IN THE MATTER OF the Panel appointed by the delegate of the Minister for Water pursuant to Part 5, Section 66 of the *Water Act 1989* (**Water Act**) to consider submissions made in respect of Works Application No AN JW1624119 (**Application**) to construct works under section 67 of the *Water Act* on or to a private dam (**Private Dam**) located at 1075 Horseshoe Bend Road, Torquay (**Property**)

#### PANEL FINDINGS AND RECOMMENDATIONS

Project: Shesepitso Torquay Dam  
 Revision:  
 Date:  
 Reviewers:  
 Respondor: Amir Farzmand (AGI)

Figure 1 - Location of Breach for Operating Level of 12m AHD and Maximum Flood Level

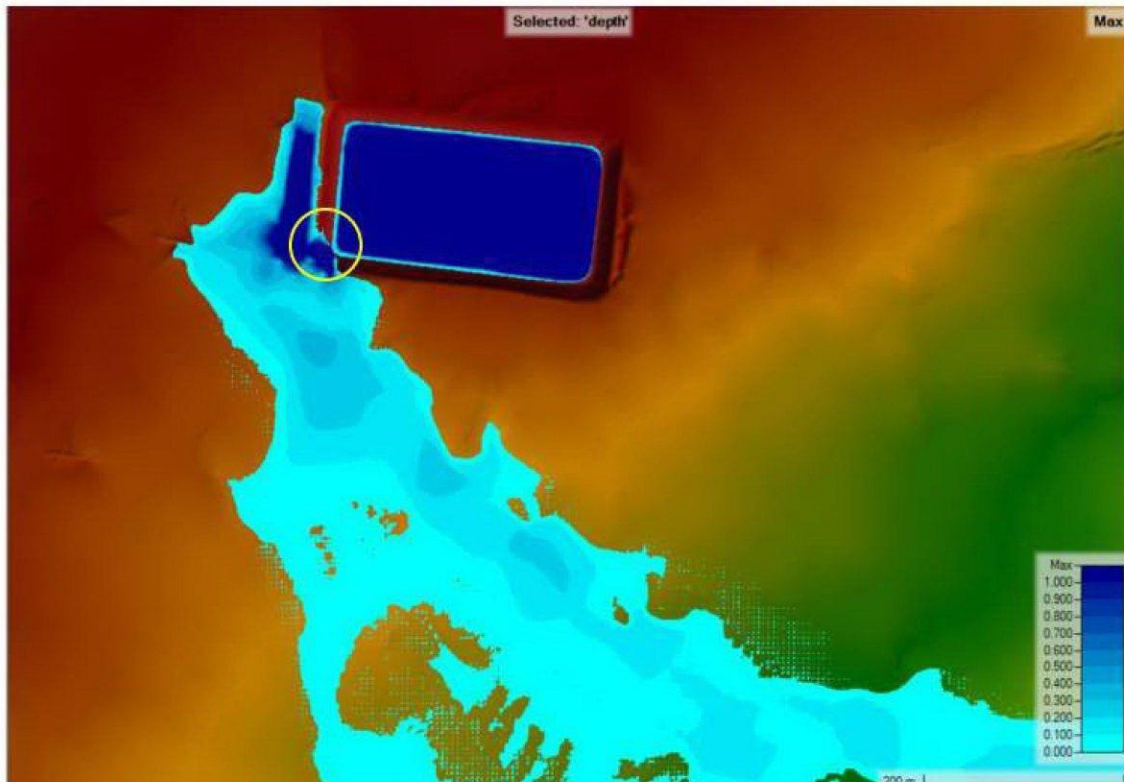
31. Mr Farazmand spoke to documents that comprised the Application and the Applicant's response to the Panel's Request for Further Information, annexed as Schedule 1. His oral evidence included the following.
- a) test results from surrounding bore logs showed no indication that the Private Dam was leaking;
  - b) modelling Mr Arash Parehkar had undertaken showed that following a failure at the south-west corner of the Private Dam, at a 12m operating level, water proximate to the rear of the residential properties might be deeper than one metre;

- c) in this scenario one dwelling might experience a high volume of water with consequential possibility of human harm;
- d) if the Private Dam failed there may be the “inconvenience” of 100mm of water impacting on surrounding properties, but certainly “less than \$10 million” of property damage;
- e) he recommended that the grass surrounding the Private Dam be kept short so that water seepage or other structural issues might be more apparent; and
- f) he also placed weight on the fact that there would be a supervisor on site regularly inspecting the Private Dam and surroundings, if not daily.
